PLANNING AMENDMENT DRAWING: 18.03.2024

18 No. - 2B Apartments,
Aspinall Street, Prescott, L34 5QQ.

Proposed Elevations (2 of 3)

DRAWING NUMBER	REVISION	DATE
4188 / SK 07	18.03.2024 J	May 2022 SCALE 1:100 @ A3

PROPOSED APINALL STREET (WEST) ELEVATION

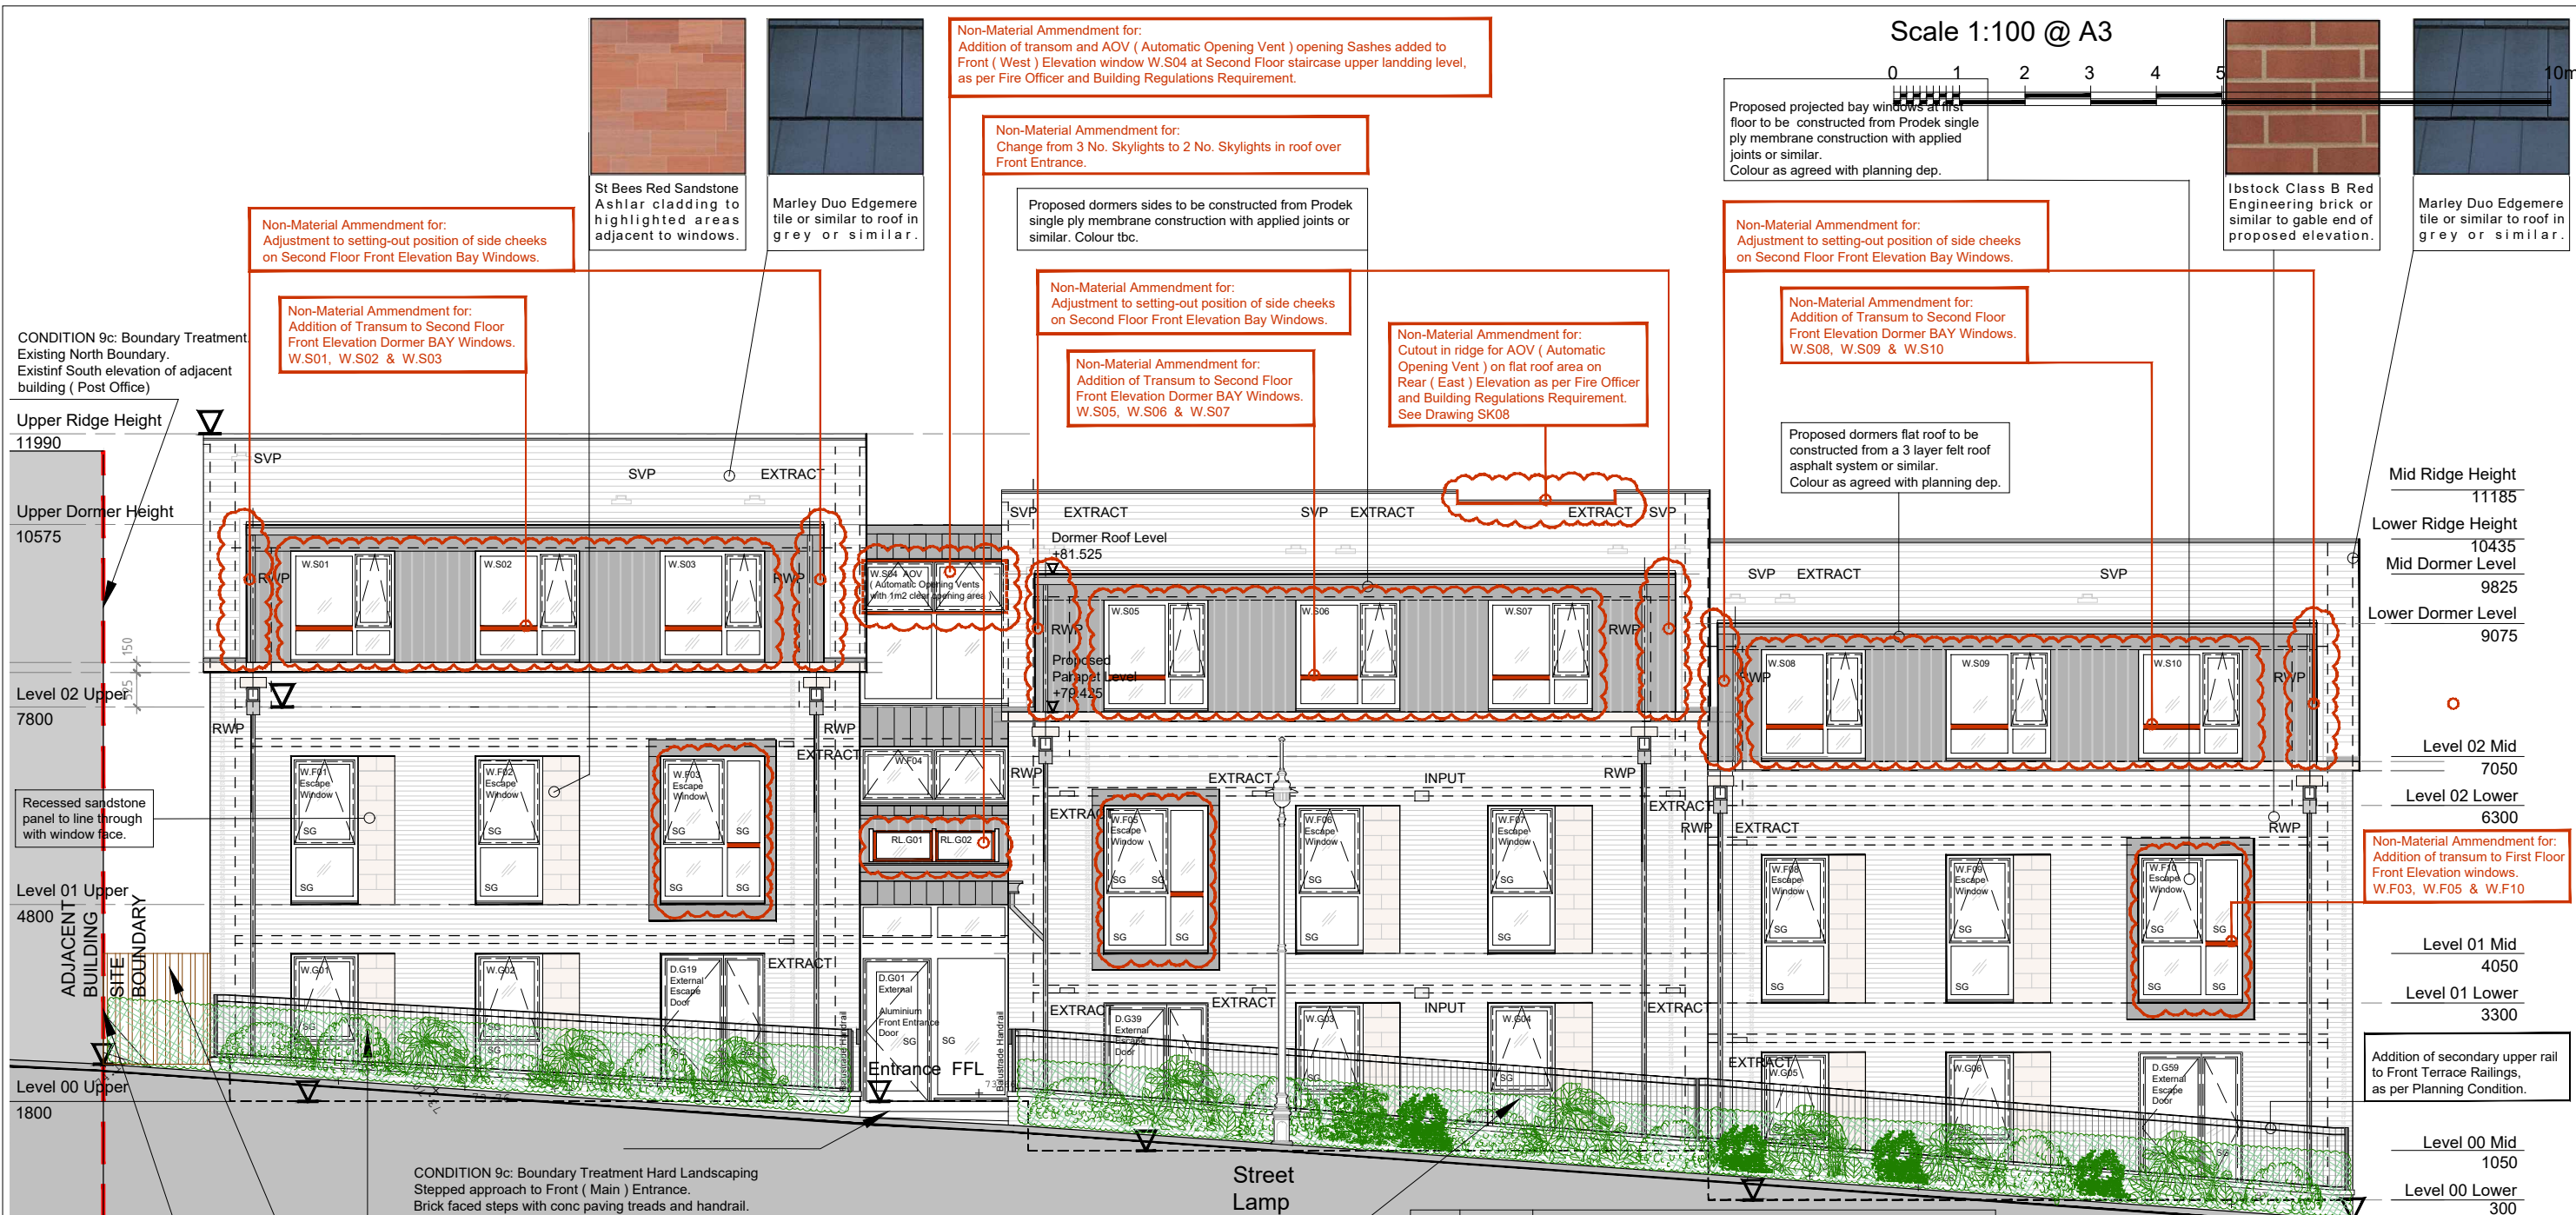
H	04.03.24	Non-Material Amendment for: Adjustment to setting-out position of side cheeks on Second Floor Front Elevation Bay Windows.
J	18/03/24	Revision and Consolidation previous notes and highlighted detail on drawing, for Non-Material Amendment Application as per Planning officers instruction. (See highlighted notes and detail in drawing)
